Section 16 Planning Application for Proposed Mixed-Use Development (Proposed Flat with Permitted Commercial Uses) with Minor Relaxation of Building Height Restriction at Lot 4354 in D.D. 124, Kiu Tau Wai, Yuen Long (Application No. A/HSK/617)

Response to Departmental Comments

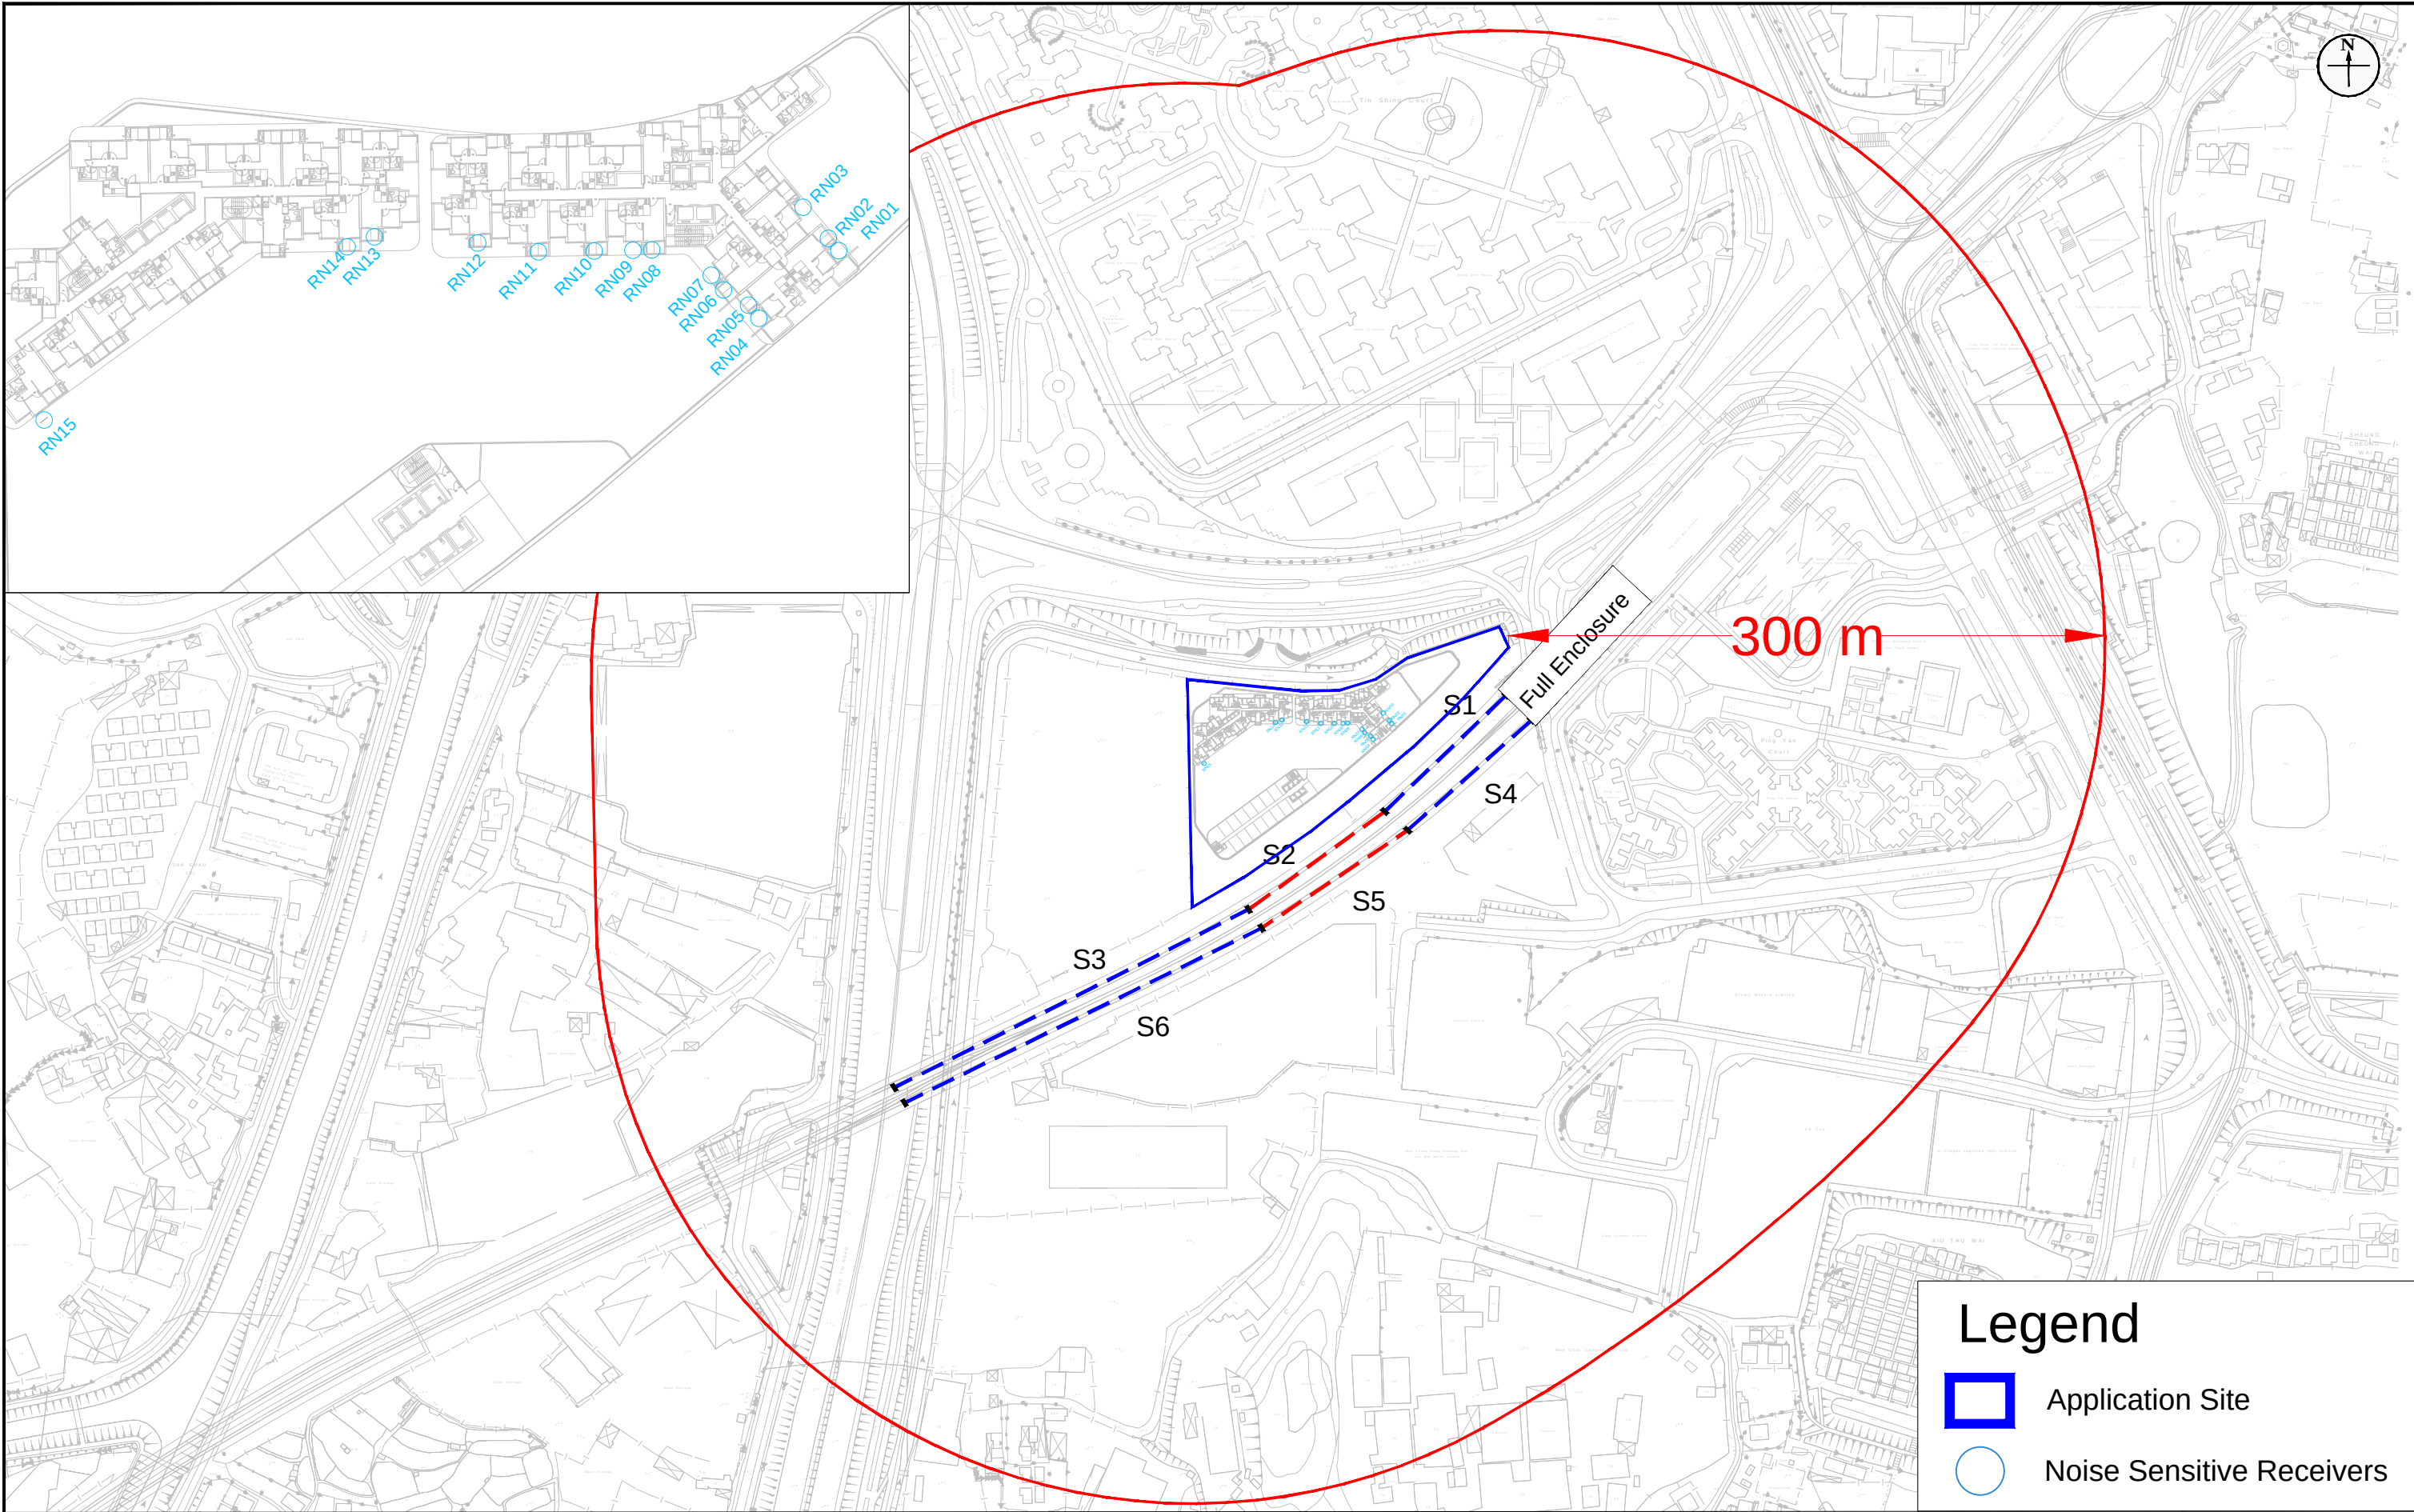
Departmental Comments	Responses to Comments
4.31	S3.4.10 – Please supplement a figure to demonstrate that all the railway track within the 300m radius of the proposed development is included in the assessment to ensure there is no underestimation on the railway impact assessment. Please review and revise as necessary.	Noted. Figure 3.1 of the EA replacement pages under Attachment 4 has been revised accordingly.

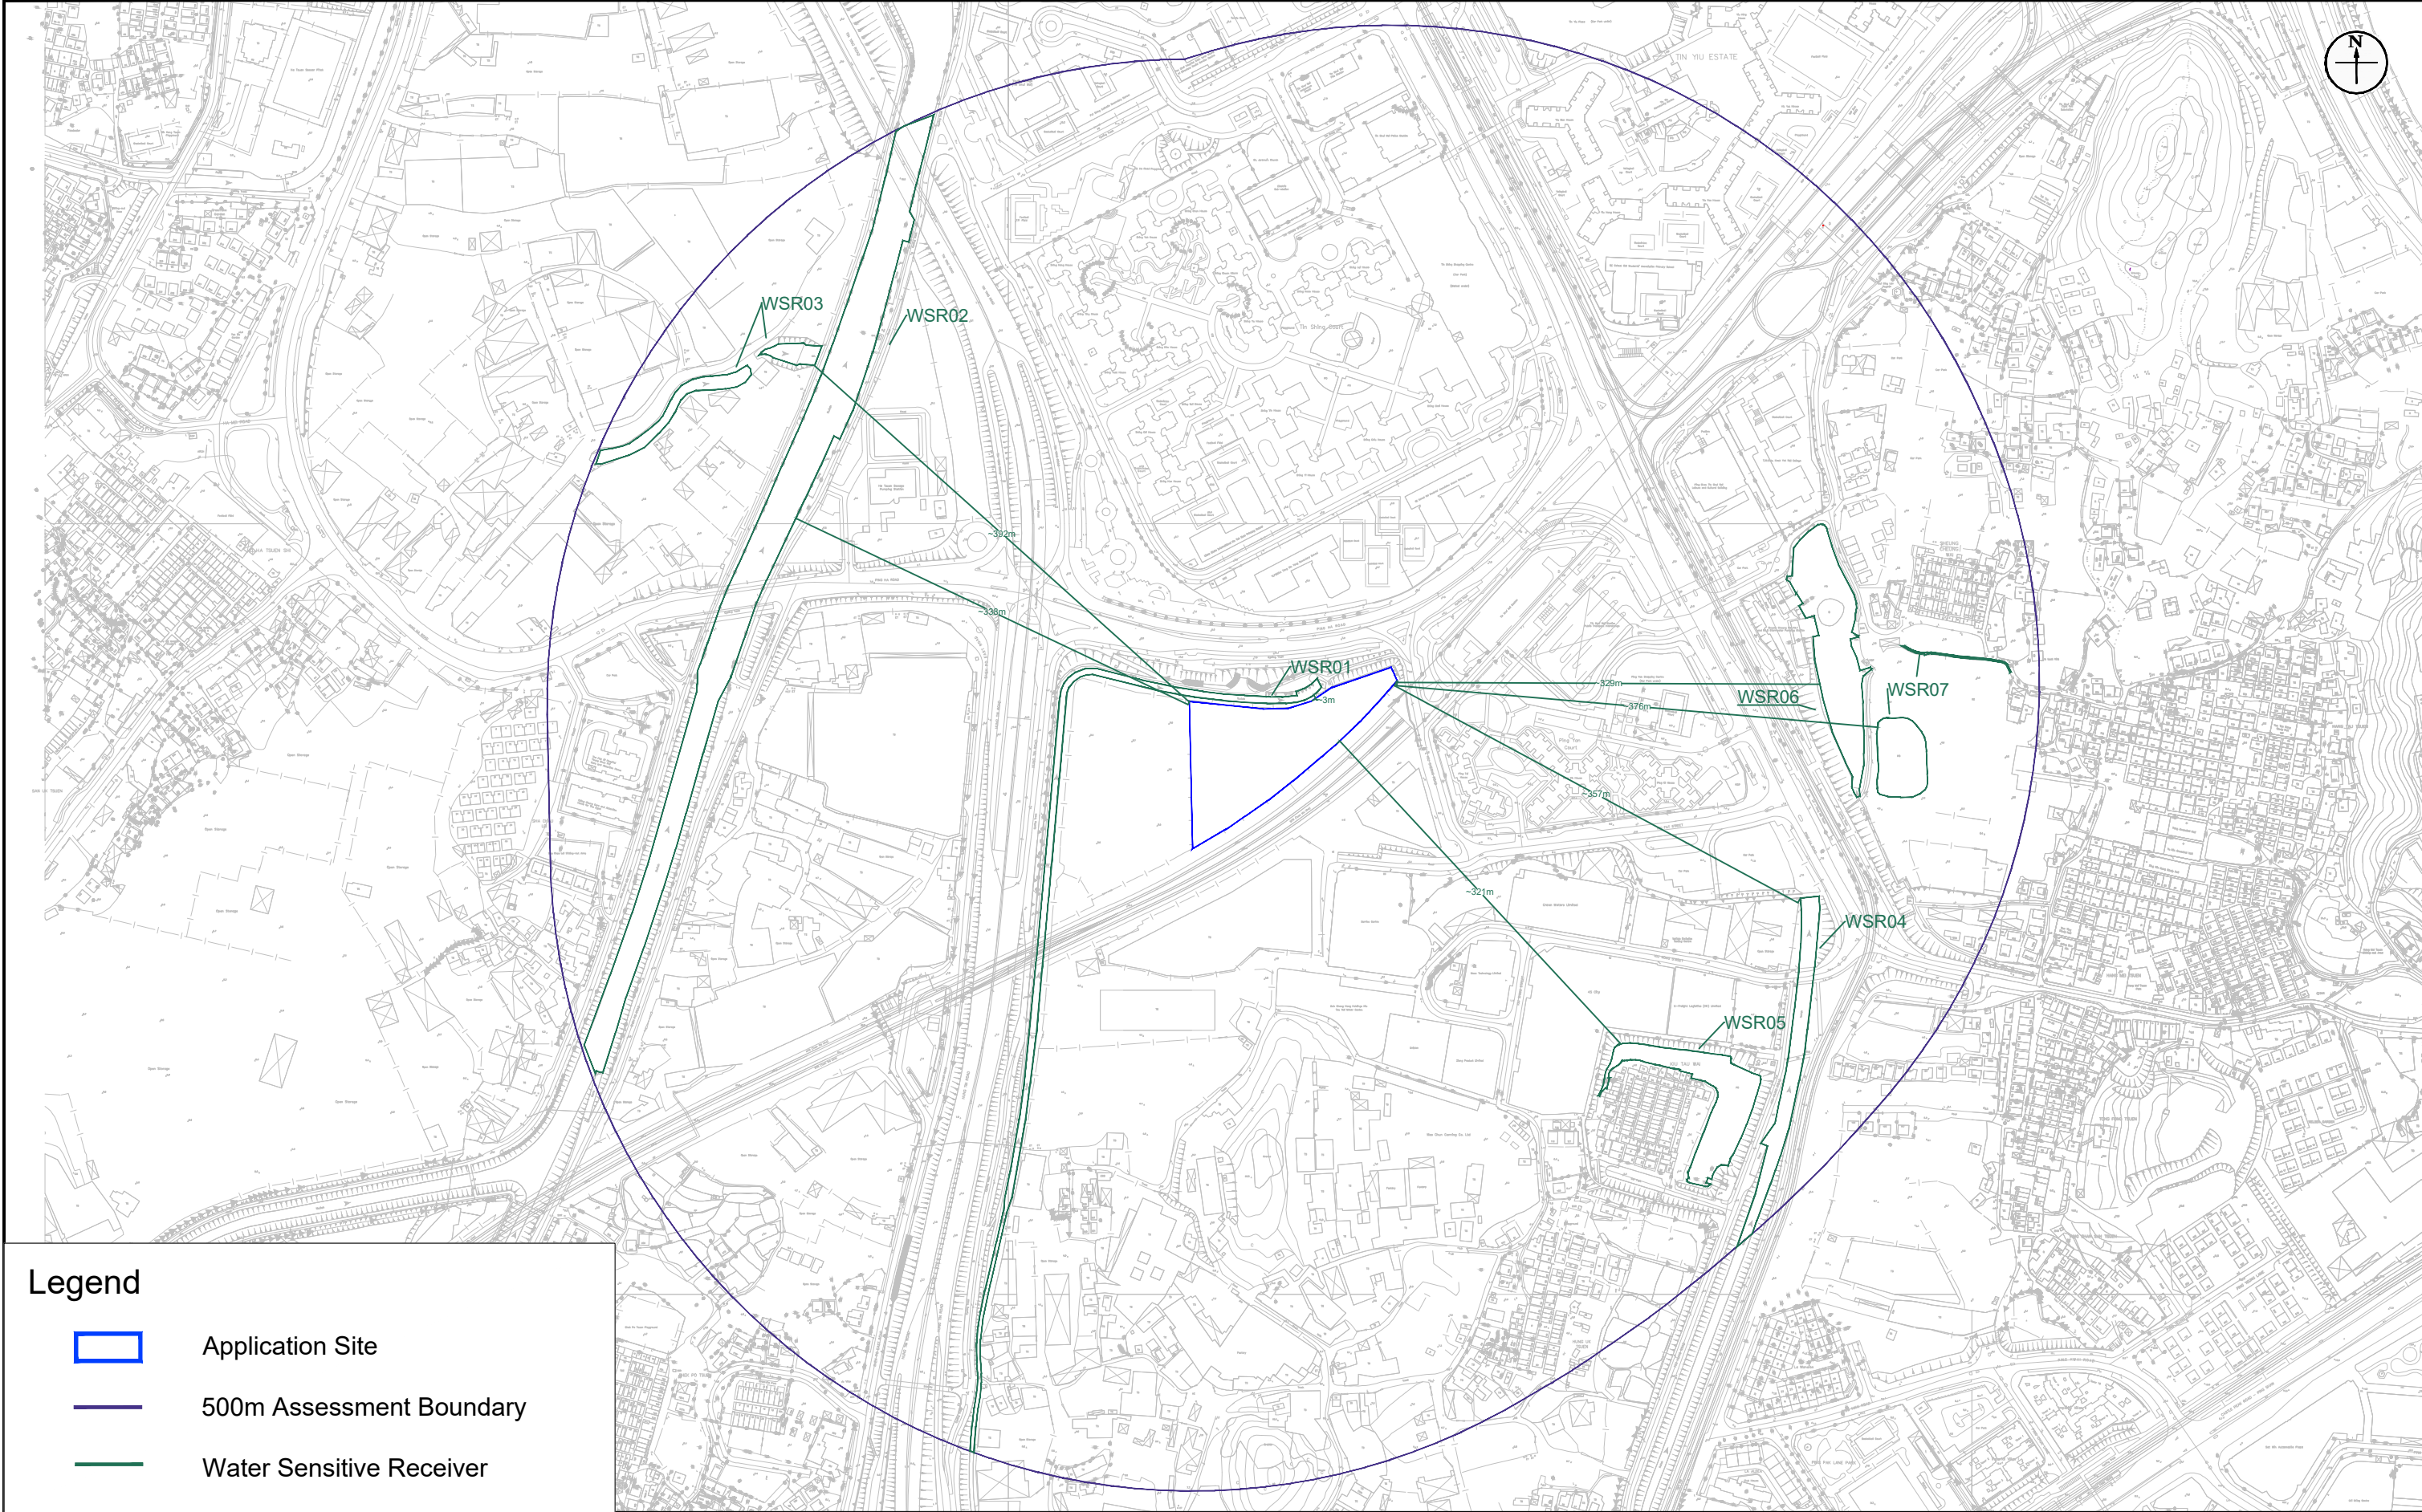
4.9	<u>Water quality</u> Table 5.1: Suggest to review if Tin Shui Wai Main Channel in the west and channel to the southeast are WSRs.	Noted. Figure 5.1 and Table 5.1 of the EA replacement pages under Attachment 4 have been supplemented accordingly.

4.21	Figure 5.1: Suggest to include the North arrow and scale.	Noted. Figure 5.1 of the EA replacement pages under Attachment 4 has been revised accordingly.

60640967/DIA/Figure 4

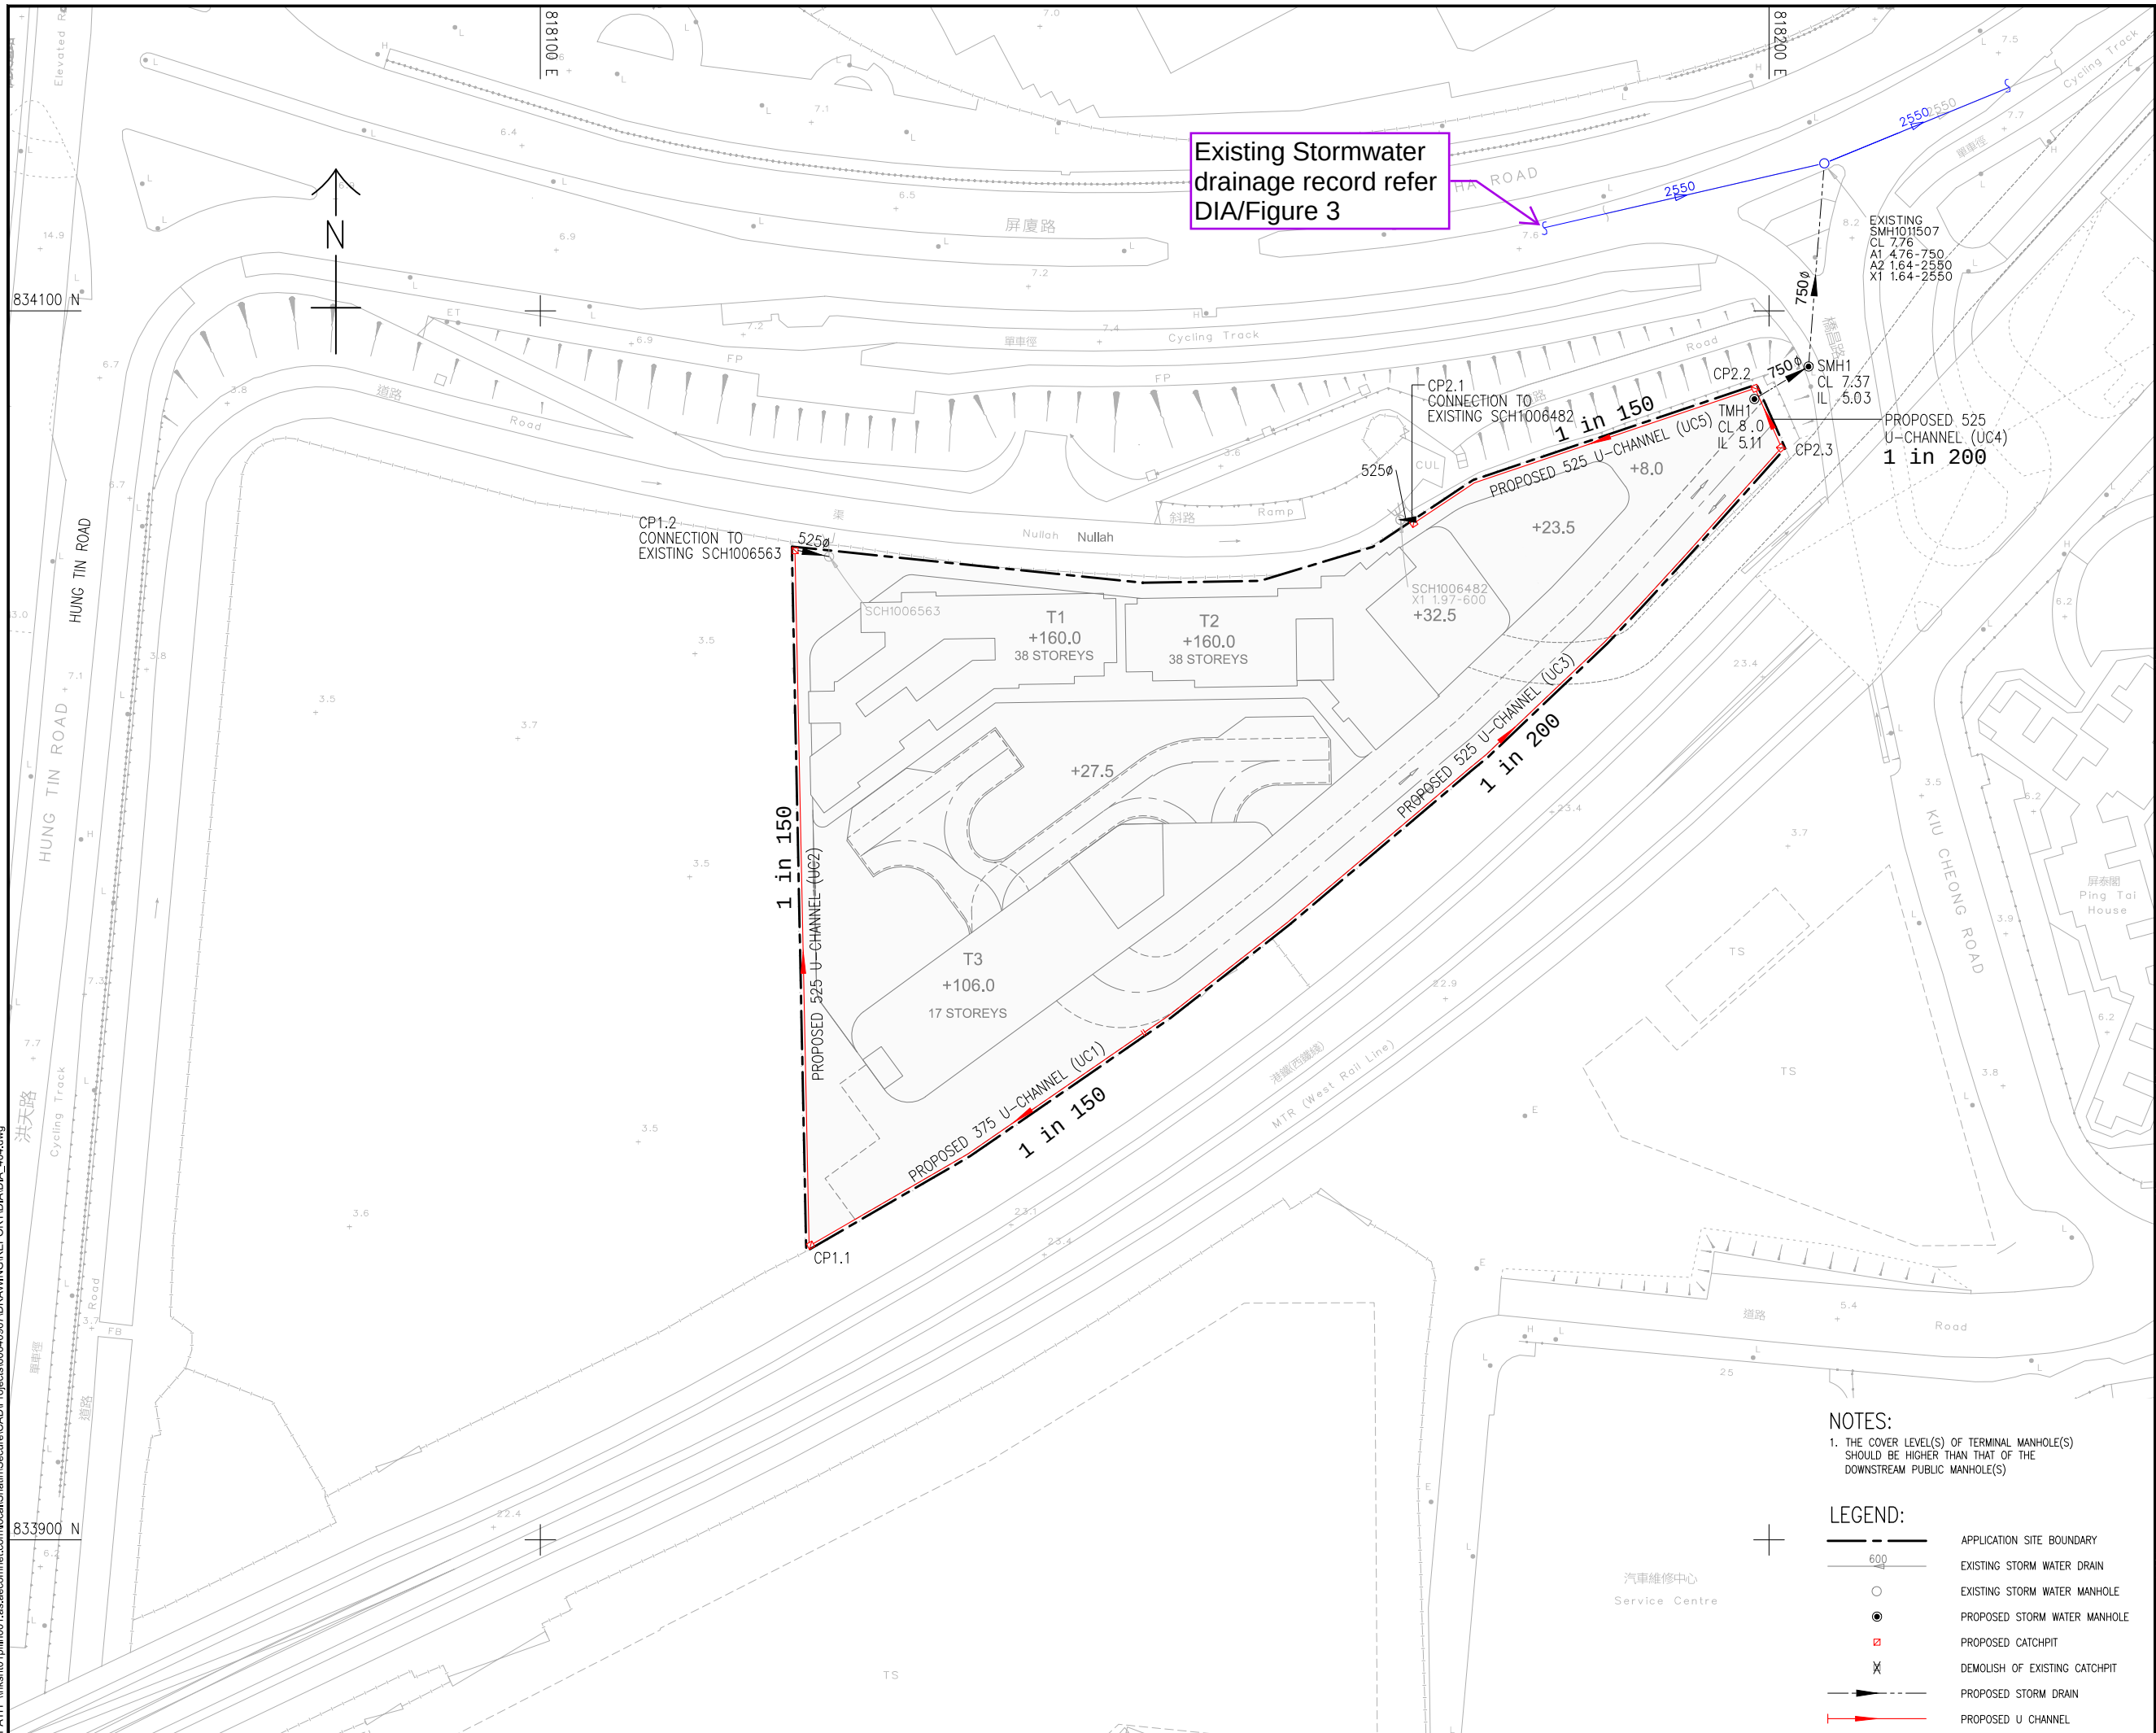
3.2	The gradient of the proposed drainage facilities shown be indicated on the drainage plan.	The gradients have been indicated on the updated Figure 4 of the DIA replacement pages under Attachment 5 .
